Great North Road Solar and Biodiversity Park

Final Statement of Common Ground with Nottinghamshire County Council

Document reference – EN010162/APP/8.1DC

Revision number 54

Figure 2. OS Historic Mapping Revised: 1972 to 1975, Published: 1974

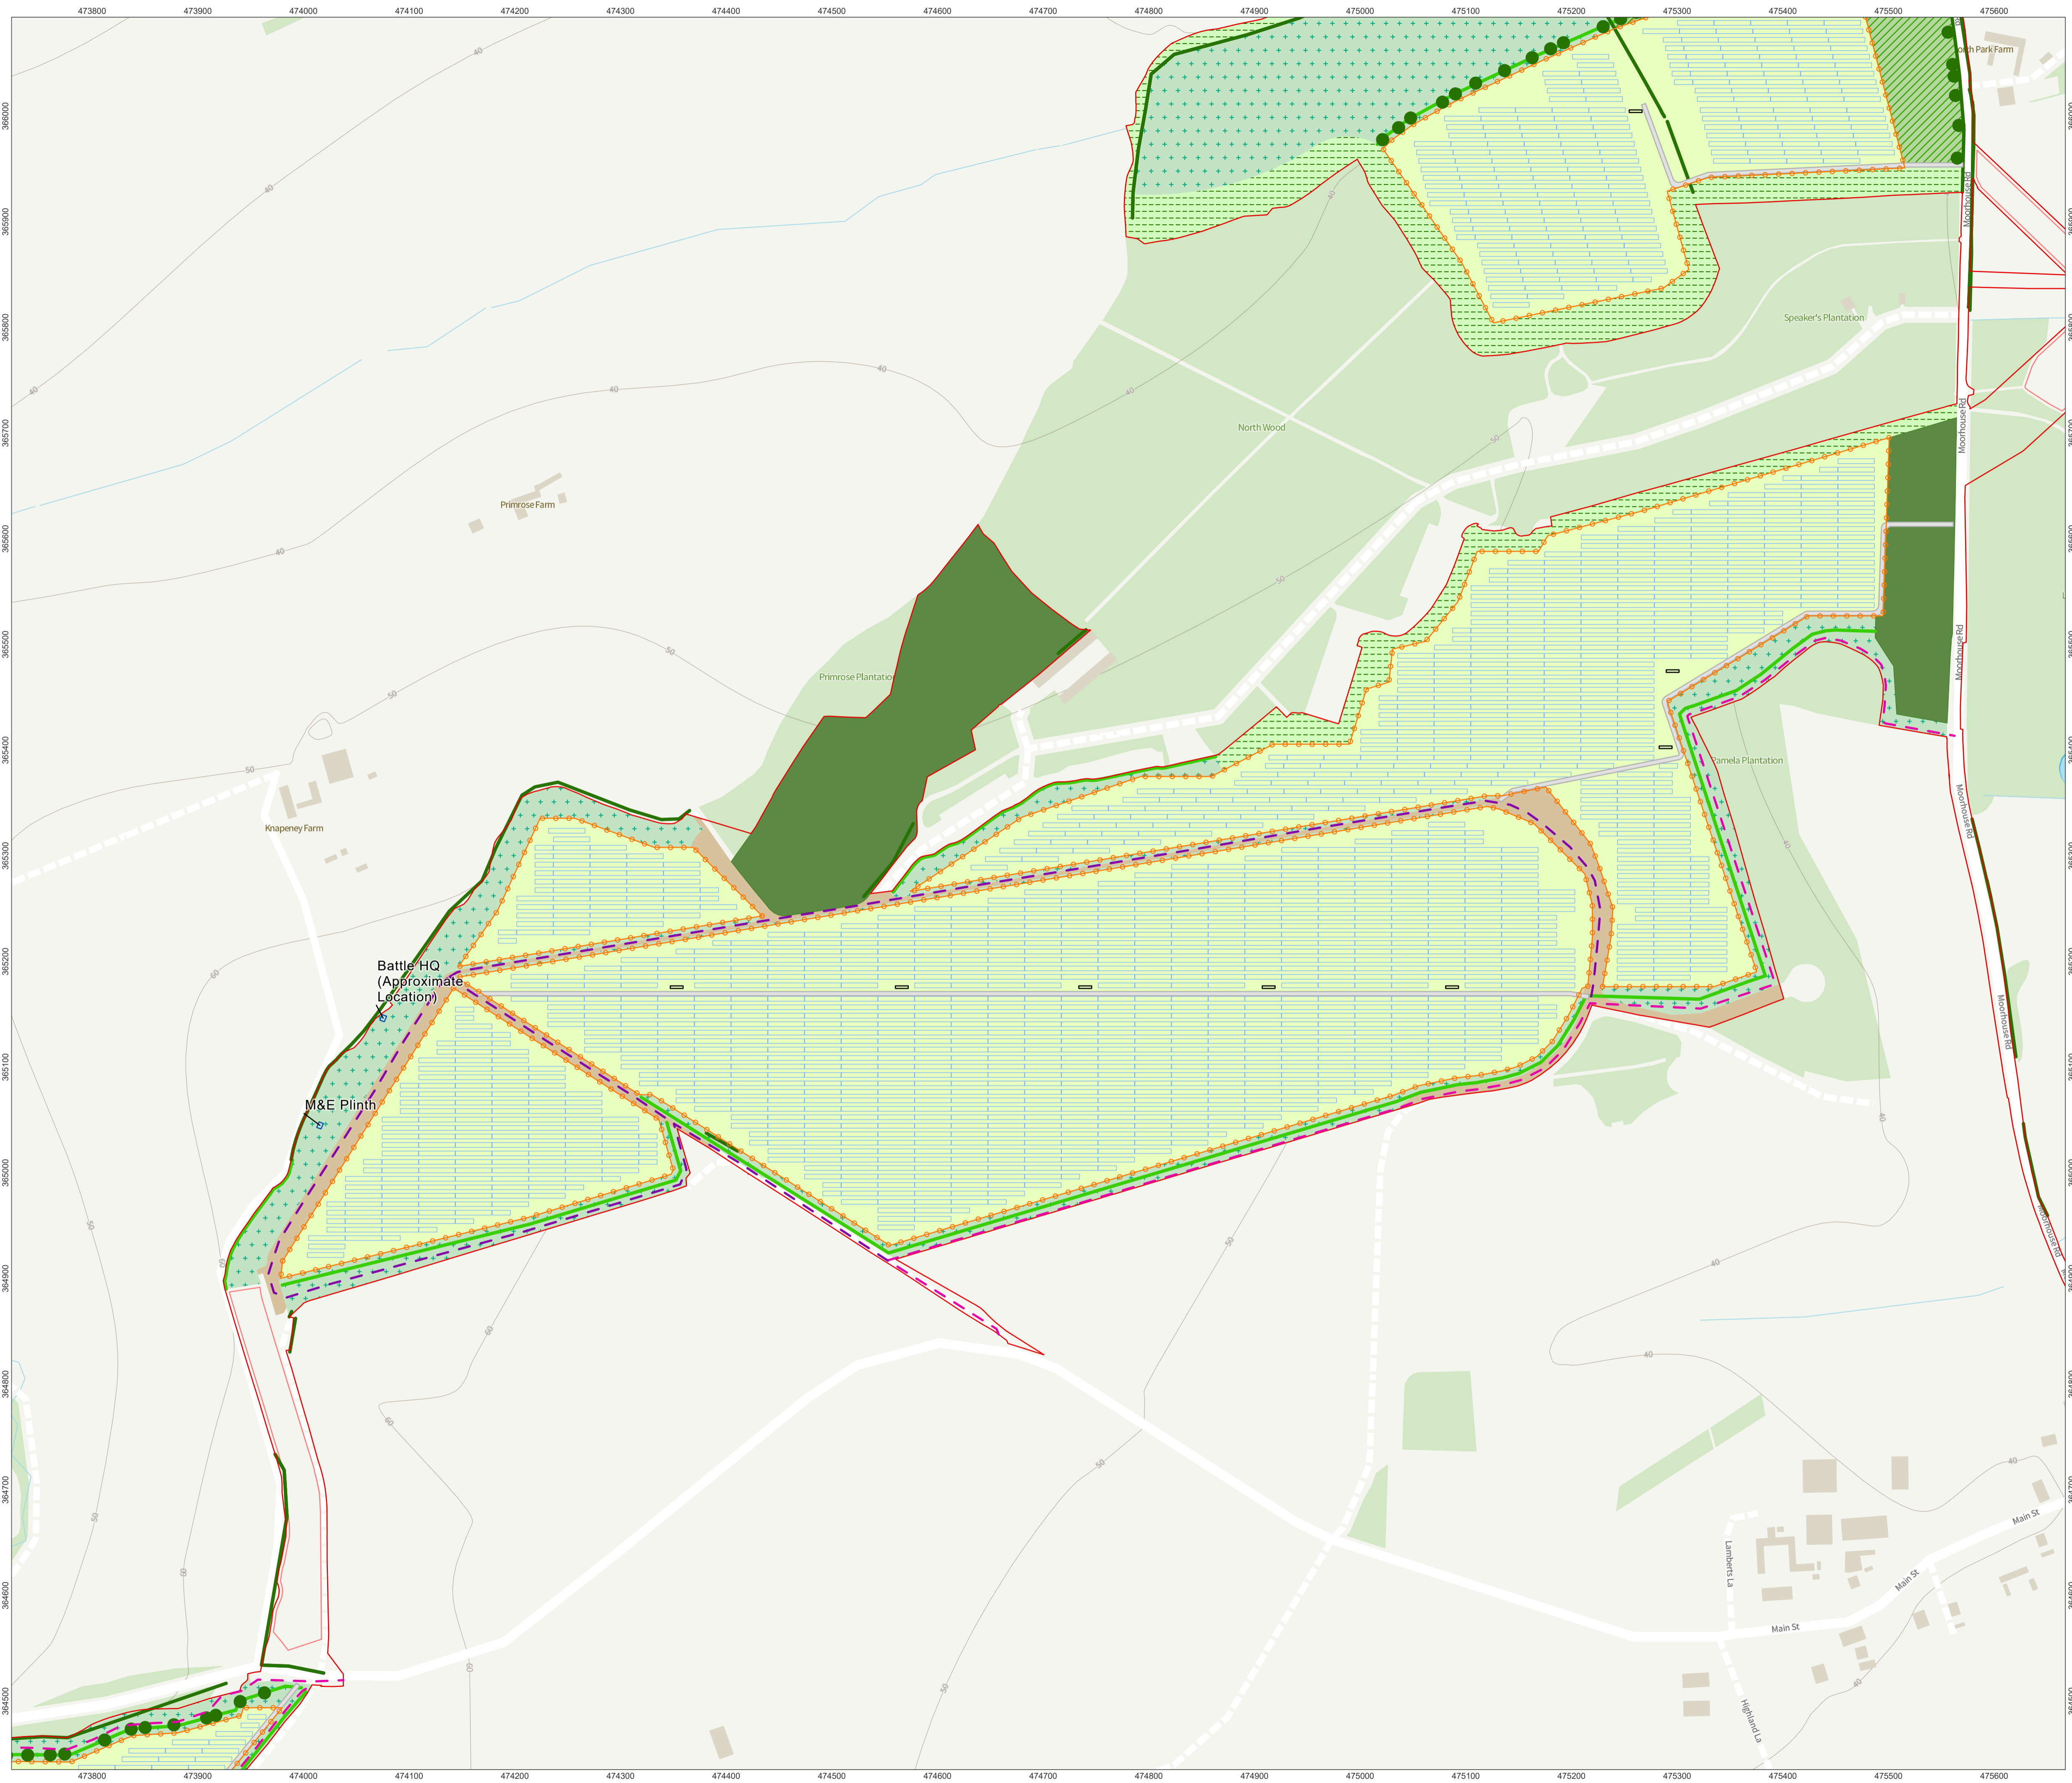
- 91 Following further discussions with NCC, the Applicant has sought the necessary agreements with the Landowner to extend the permissive path within the Airfield site. The extended proposal now allows for a circular route, using the perimeter track along the northern and eastern parts of the Airfield site, with a spur along the main runway line from the access point at the Memorial (which lies just outside of the Order Limits). This extended route is shown on the Figure appended to this Statement, with the originally proposed line in pink, and the extended proposed paths in blue.
